Board of Mayor and Aldermen
July 18, 2024 Special Meeting @ 5:30 PM

Item #: 7.C. Approve Change Order #3 with Baron Construction, LLC for the Public Works and Community Development Services Facility.

This is a change order for the construction of the Public Works and Community Development Services Facility.

Drawing Number(s): A102

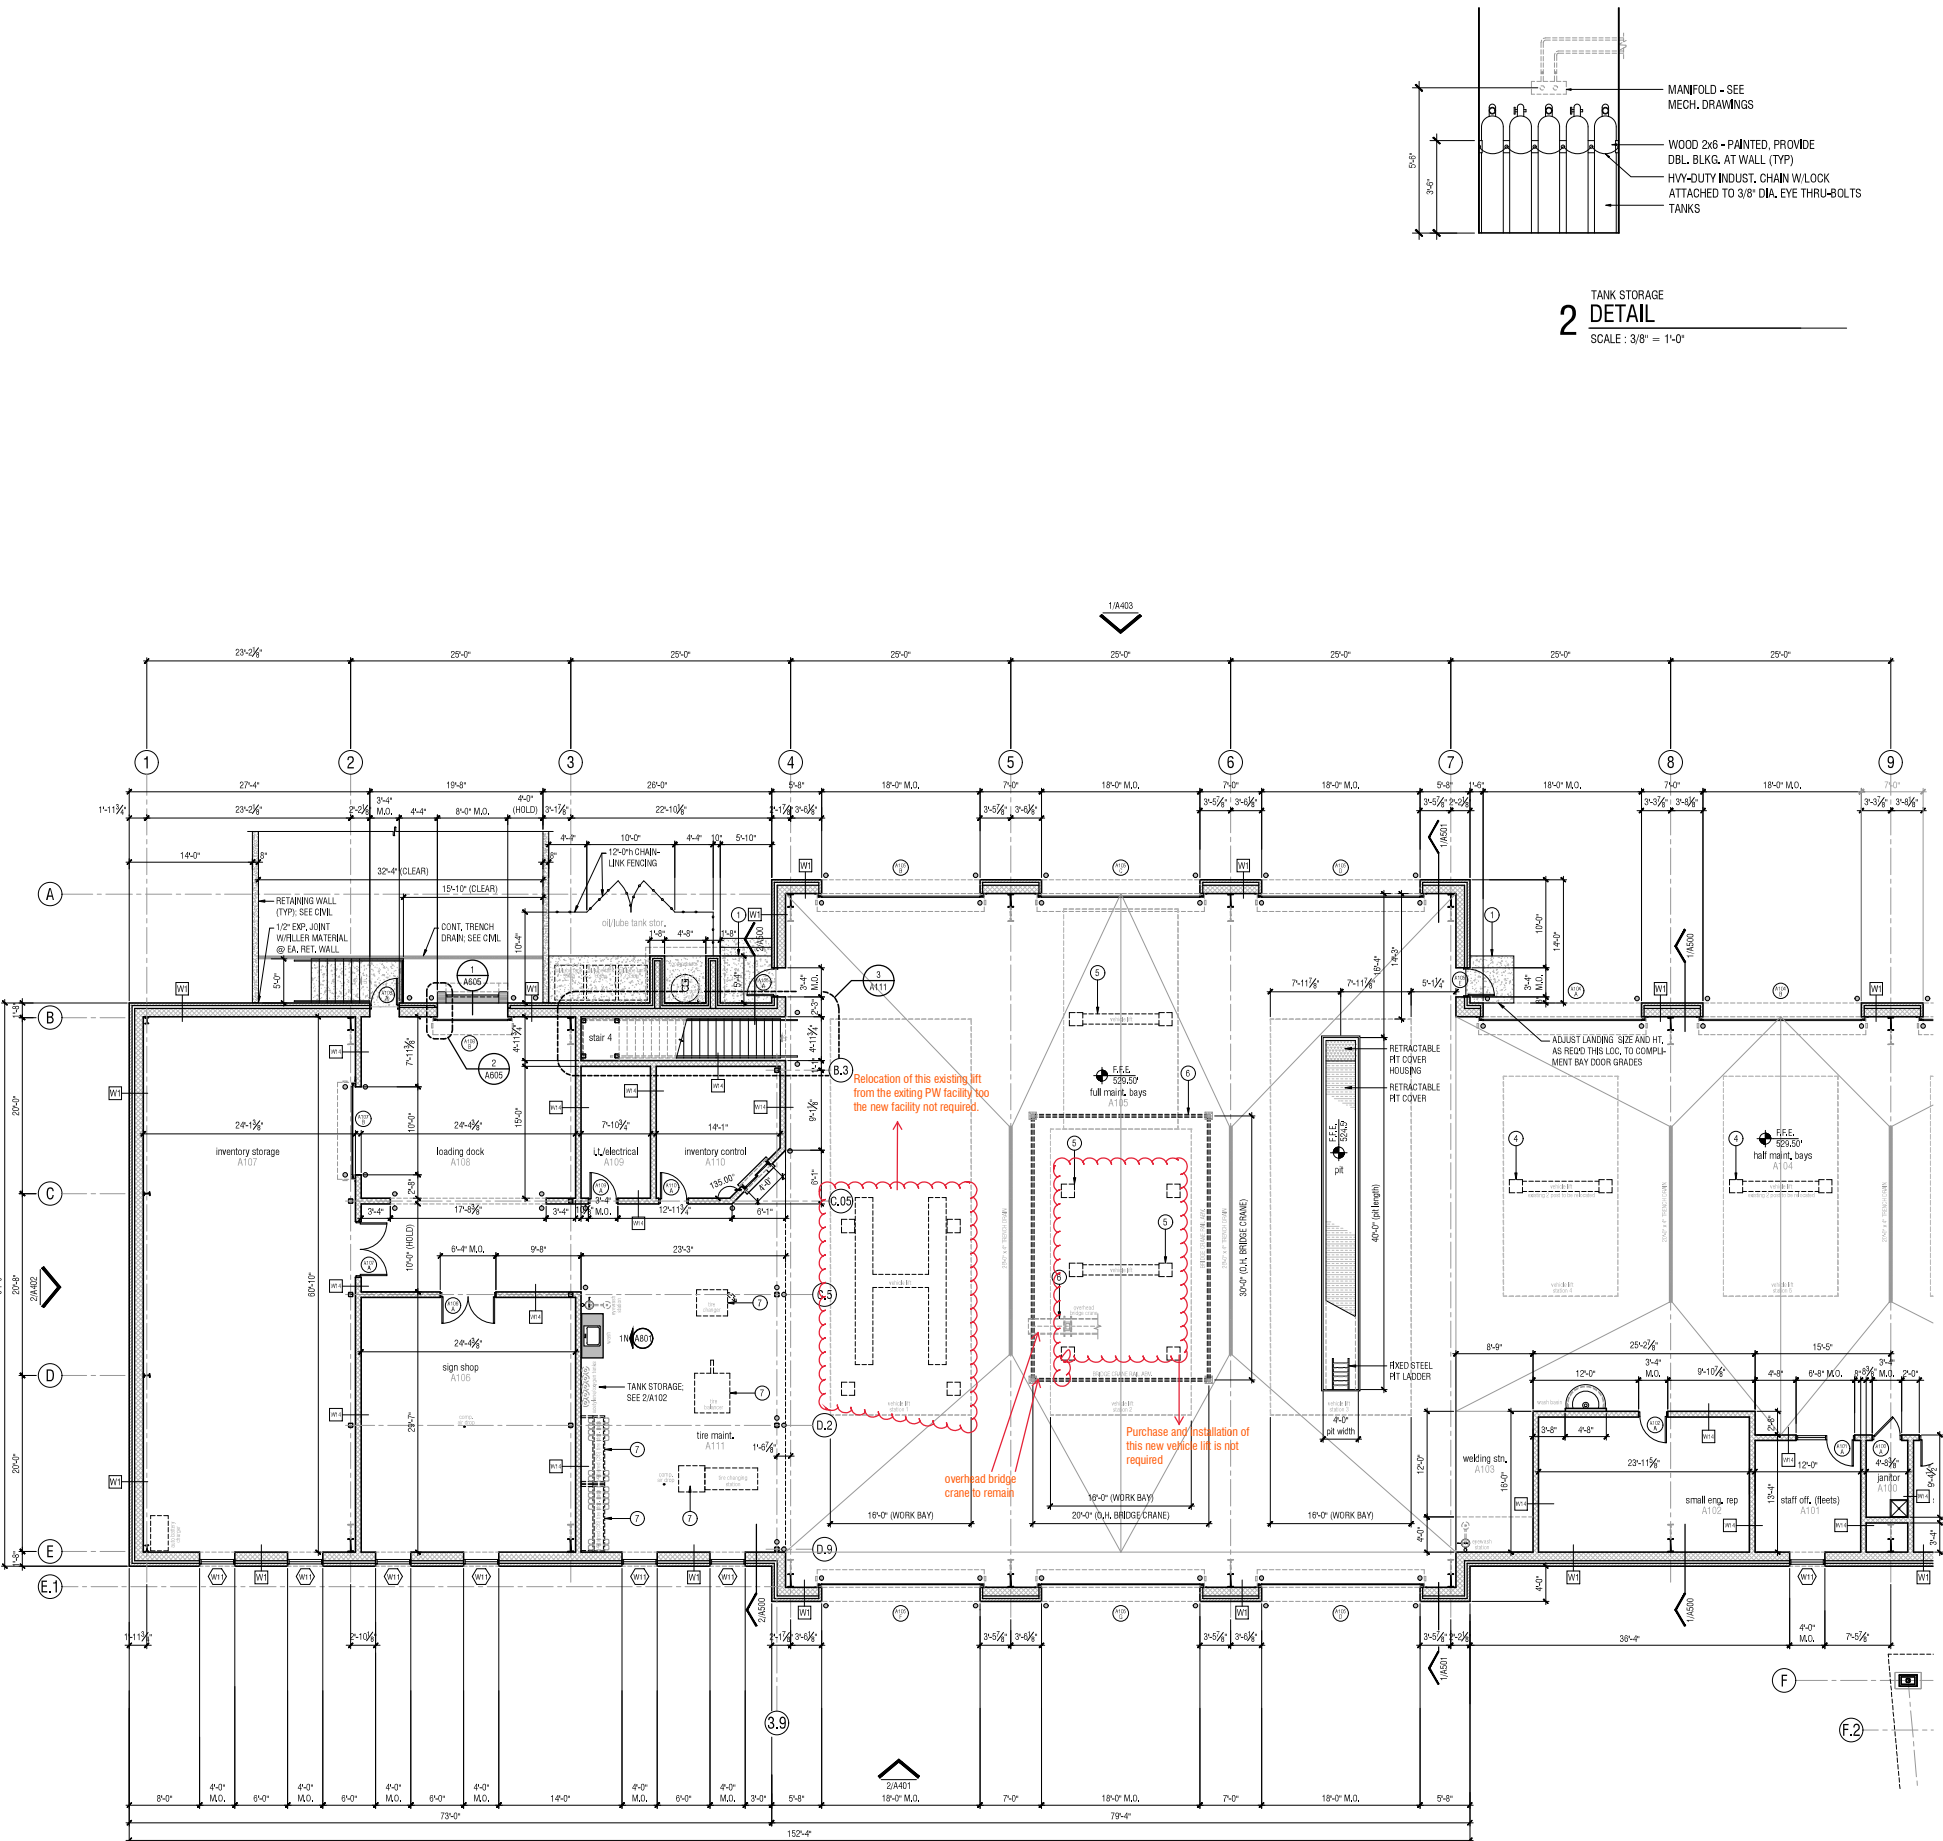
Description: Delete Vehicle Lifts

DELETE: Please provide a credit to delete the labor and all associated costs to relocate the existing lift from the existing PW facility to the new facility as shown on the attached drawing (*sheet A102*), and the labor, equipment, and associated costs to furnish and install the new vehicle lift as shown on the attached drawing (*sheet A102*).

NOTE: Electrical and/or other utilities feeding these lift locations shall remain as specified under the Contract Document

AREA A - ADDITIONAL
UNDERCUT/BACKFILL OVER
PREVIOUS RFC 15 QUANTITIES

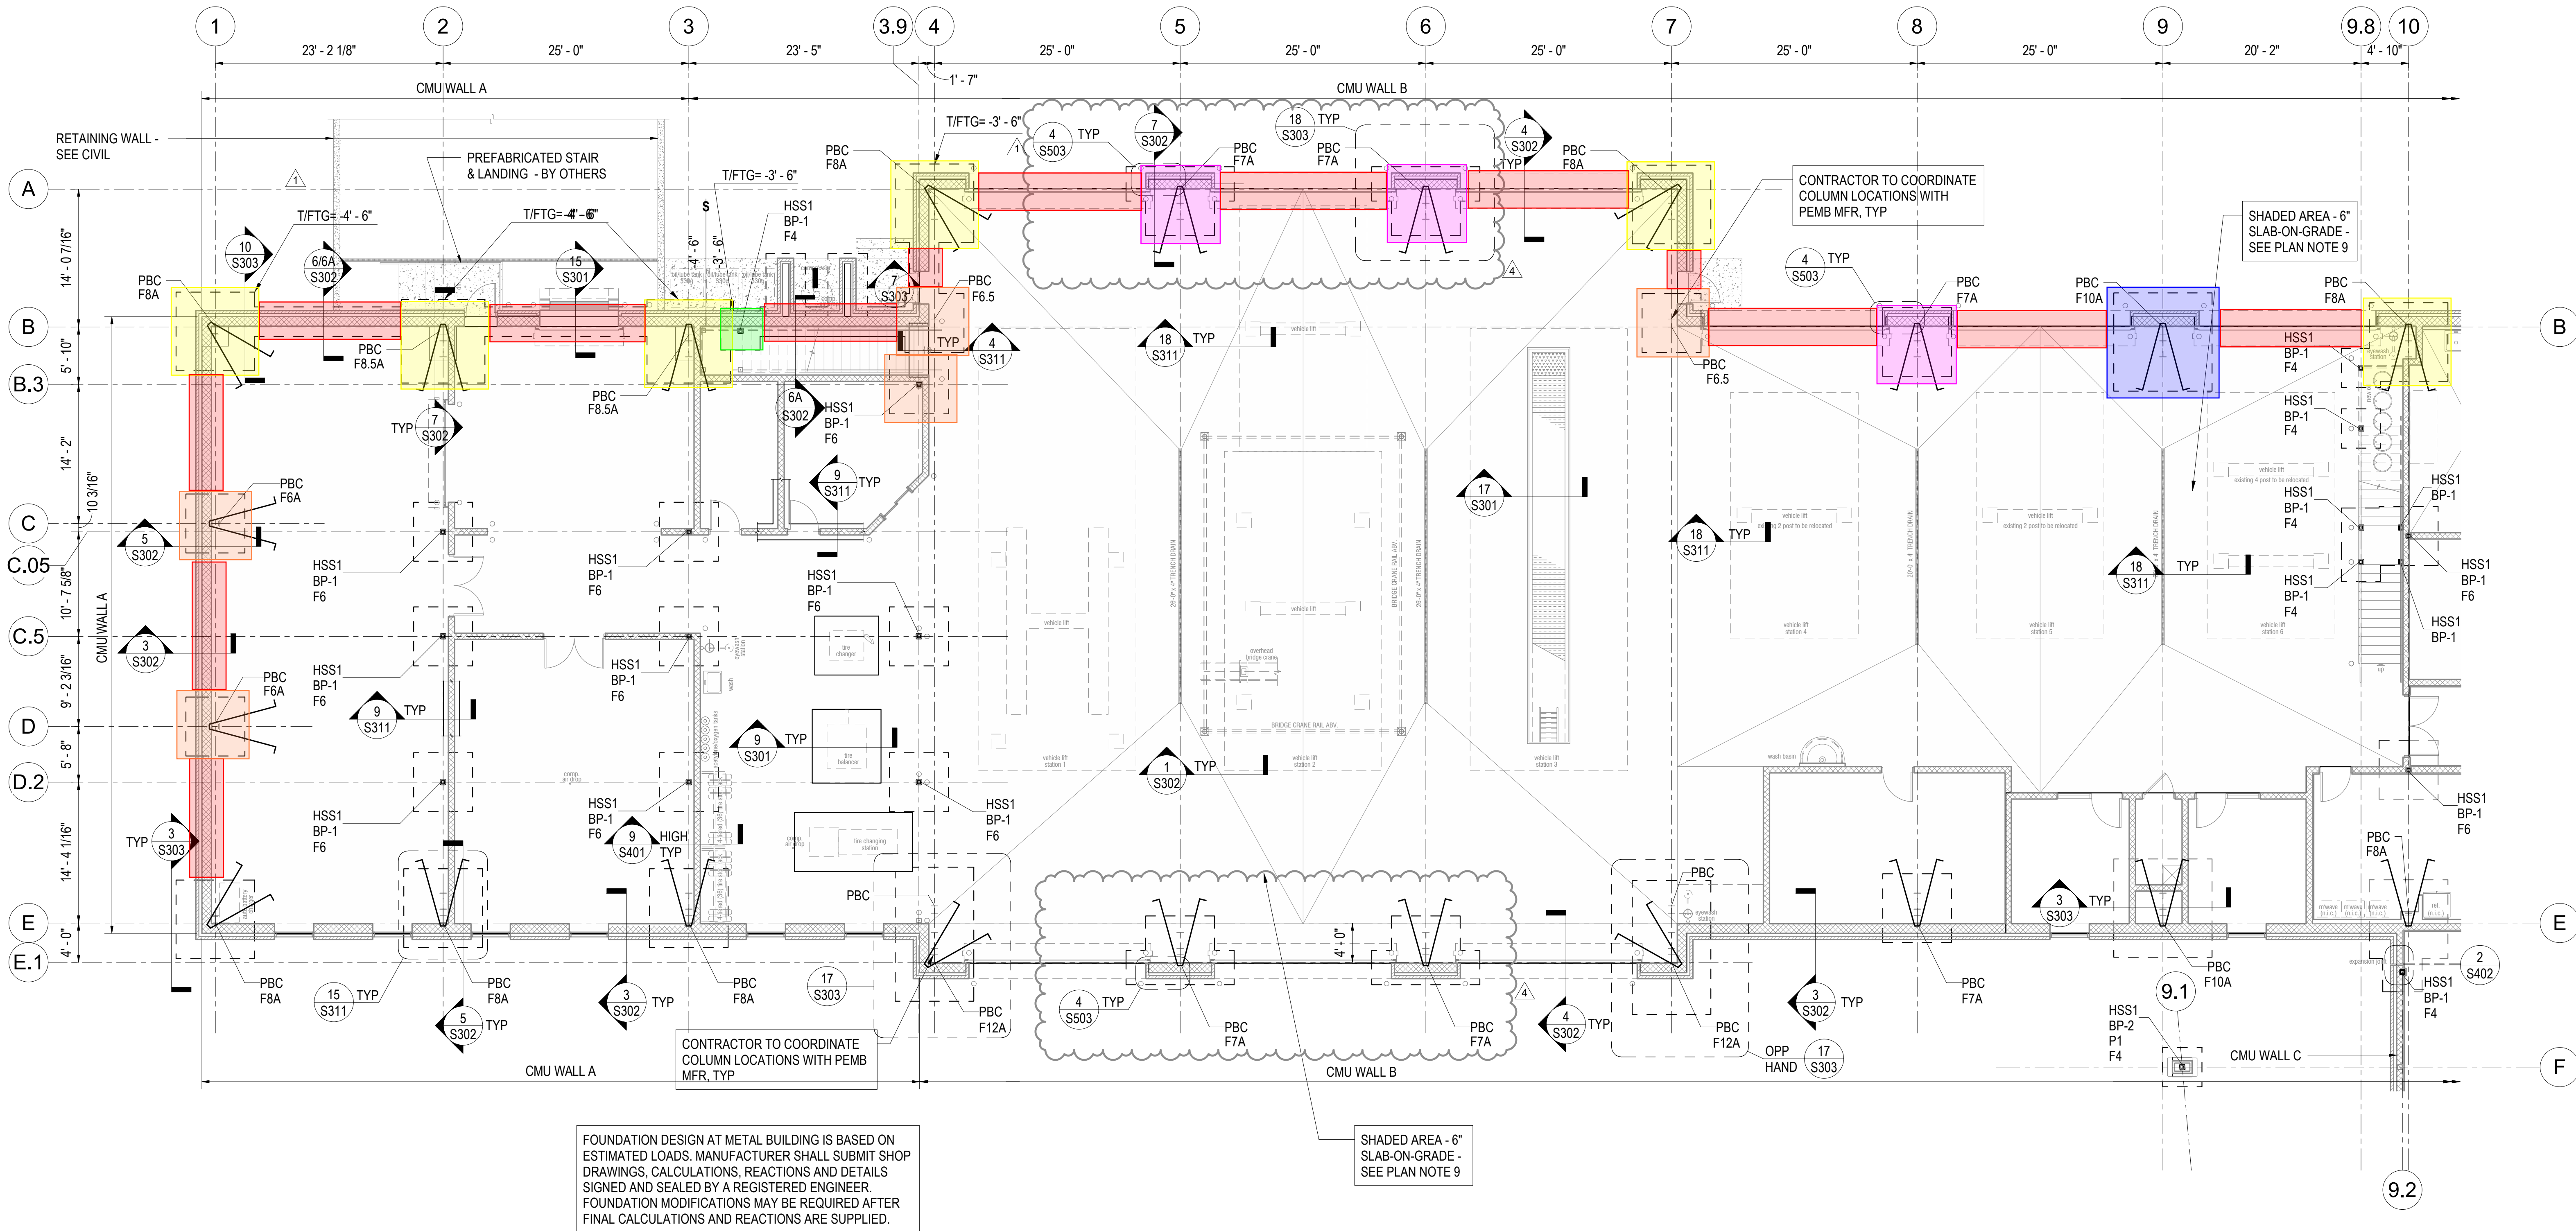
Footer Undercut & Backfill in Area B, and additional in Area A (over previously submitted RFC 15 quantities). Undercut and backfill with approved fill under supervision of TTL Technician on site, per TTL reports and CEC email recommendation/directive. This includes the eastern end of Area B where modified detail E-16 was used with additional concrete thickness below bottom of footer elevation

As discussed on our call this morning, we have prepared a sketch depicting our recommendation for how to approach the concerns identified in Footing E-16 related to a subsurface seep. Please note that this sketch only applies to Footing E-16 and we may need to provide additional guidance if this happens again somewhere else onsite.

RFI #59: Mens Toilet B117 Dimensions

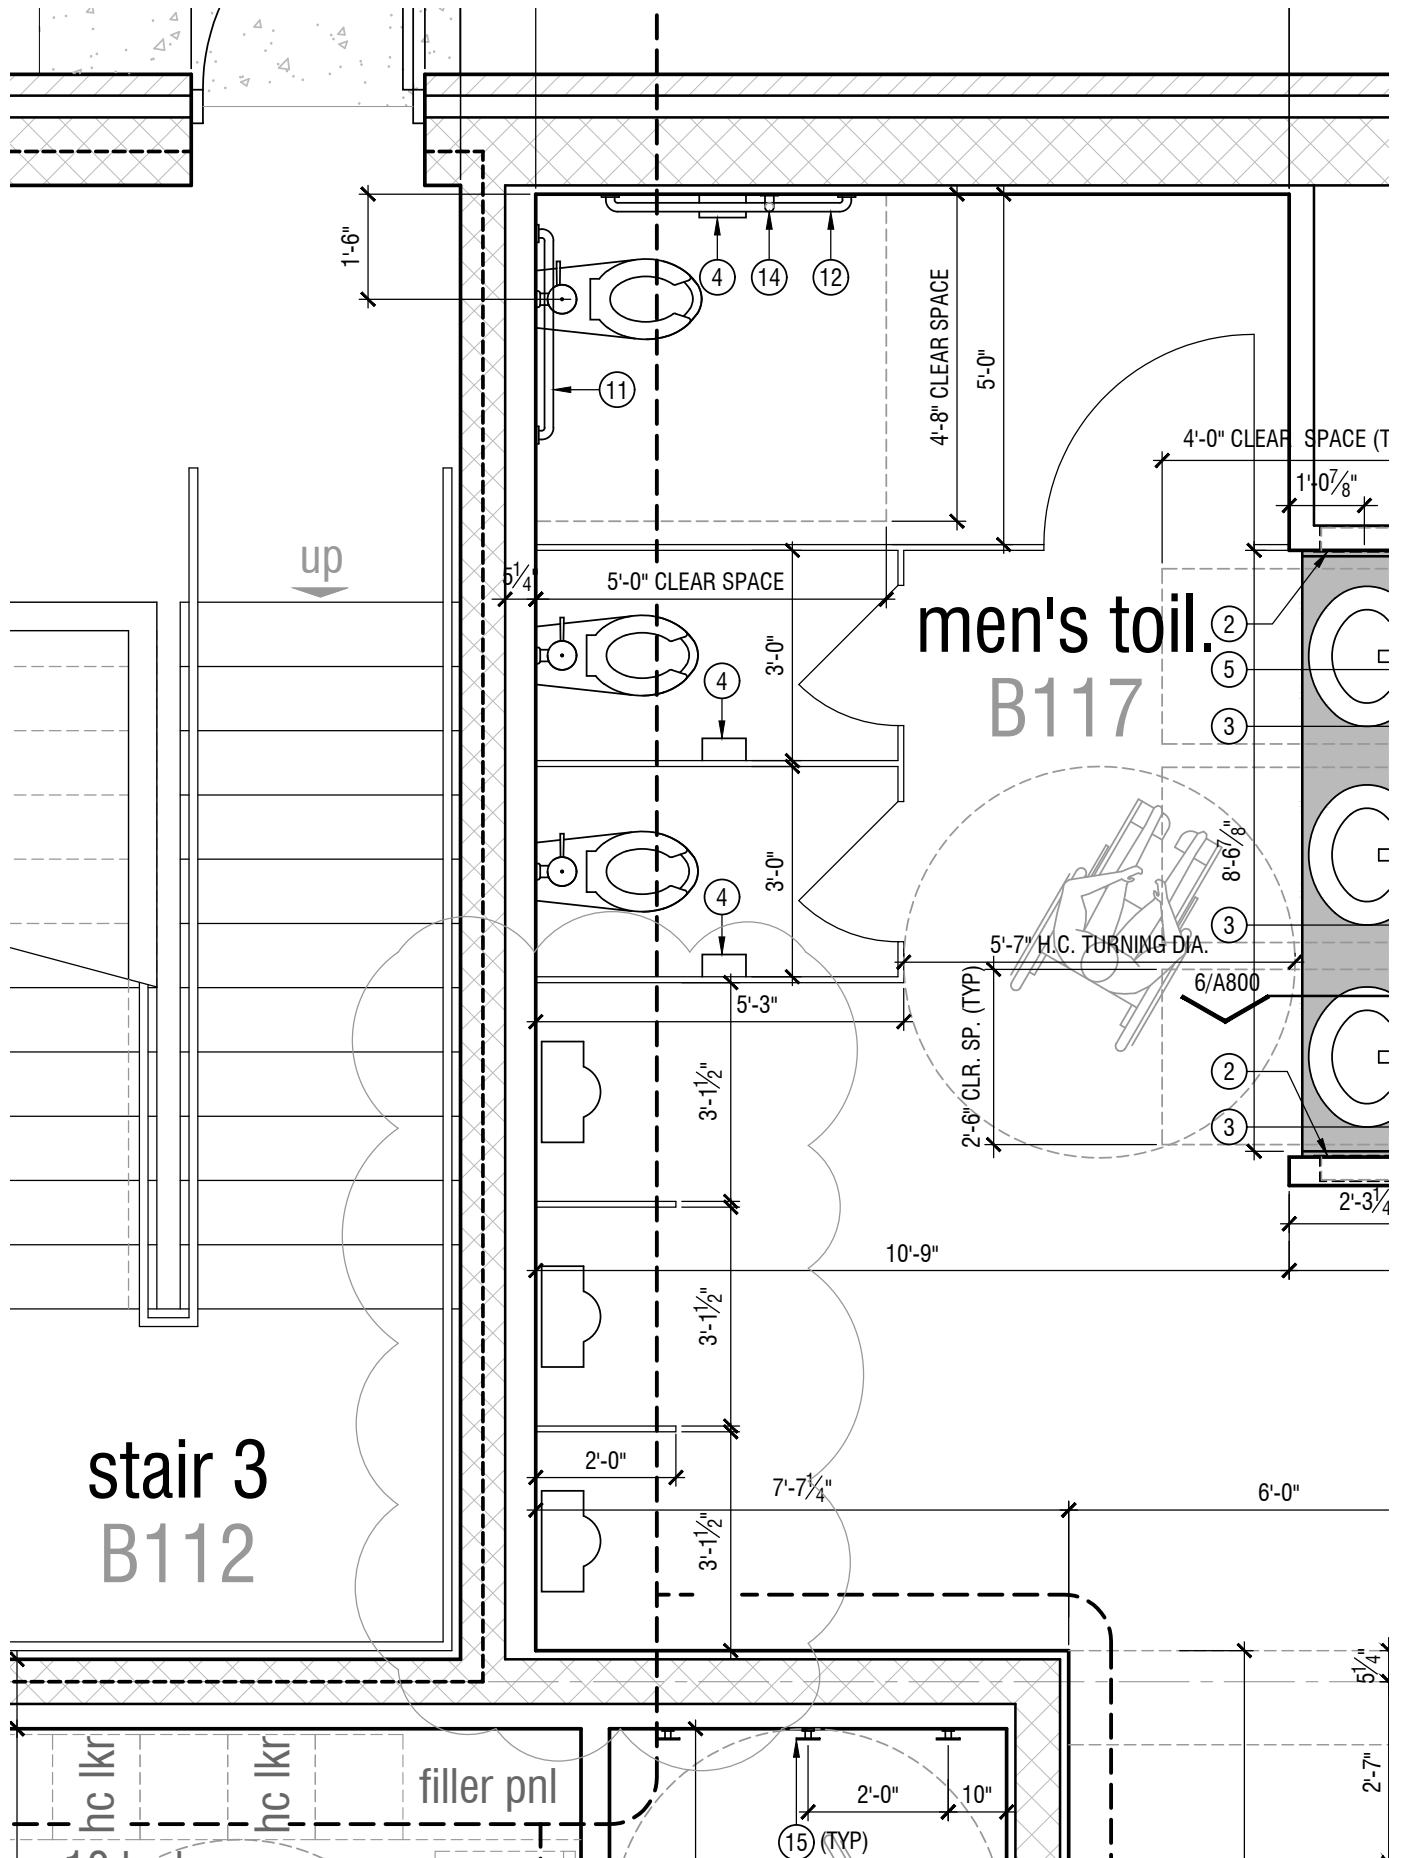
Question	Question from Roy Bruce Baron Construction, LLC on Monday, Mar 4, 2024 at 08:51 AM CST Tim, The spacing of the urinals in Men's Toilet B117 (see sheet A108) is shown as 2' - 3 7/8" inside to inside. The plumber is saying code is 30" spacing meaning we appear to need an additional 2 1/8" to meet code. This appears to be the only bathroom with this situation. Please confirm how we are to proceed in this area - is it acceptable to use the spacing shown for rough in? If not, what do we need to change?
Official Response	Response from Tim Lambe Lambe & Associates, LLC on Monday, Mar 4, 2024 at 10:28 AM CST Revise per attached sketch; we're fine on our fixture counts. Please issue an RFC for the credit. Attachments 030424 RFI-59 Response.pdf

*** DELETE 1 – URINAL IN MENS TOLIET B117 AS PER RFI #59**
